REQUEST

Current Zoning: R-3 (residential)
Proposed Zoning: R-8MF (CD) (multi-family residential, conditional)

SUMMARY OF PETITION

The petition proposes to rezone approximately 41.5 acres to a conditional multi-family district to permit the construction of up to 200 single family attached dwelling units at a density of 4.81 dwelling units per acre (DUA).

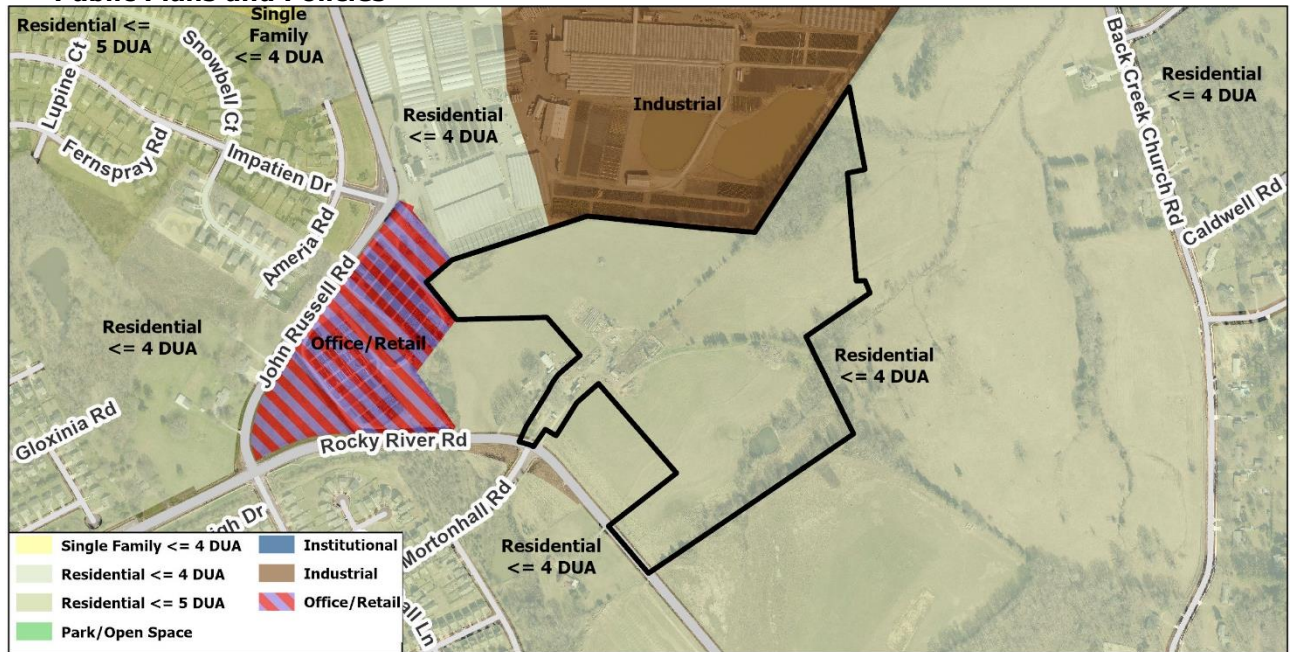
1. ~~Correct acreage for Tree Save on Sheet 1. Acreage should be .97 and 150 percent of that number results in 1.305 acres replanted.~~ **ADDRESSED**

2. ~~Remove "reverse frontage buffer" from legend as it no longer exists on the plan.~~ **ADDRESSED**
3. ~~List only the minimum required open space on the plan on both Sheet 1 and 2.~~ **ADDRESSED**
4. ~~Add ½ 100' Class A buffer label along the eastern portion of the rezoning boundary.~~ **ADDRESSED**
~~Clarify why buffers are notched along the site's northern rezoning boundary. Reduction only allowed with construction of berm.~~ **ADDRESSED**
5. ~~Clarify whether driveway access from Rocky River is being dedicated as ROW. If not, buffers will be required.~~ **ADDRESSED**
6. ~~For note IV.8, replace "should" with "shall" or remove note in its entirety.~~ **ADDRESSED**
7. ~~Rename "lead walks" to sidewalks or a term more familiar to the review team.~~ **ADDRESSED**

8. **Site plan and conceptual plan should illustrate the proposed stub street to the south of the site as constructed.**
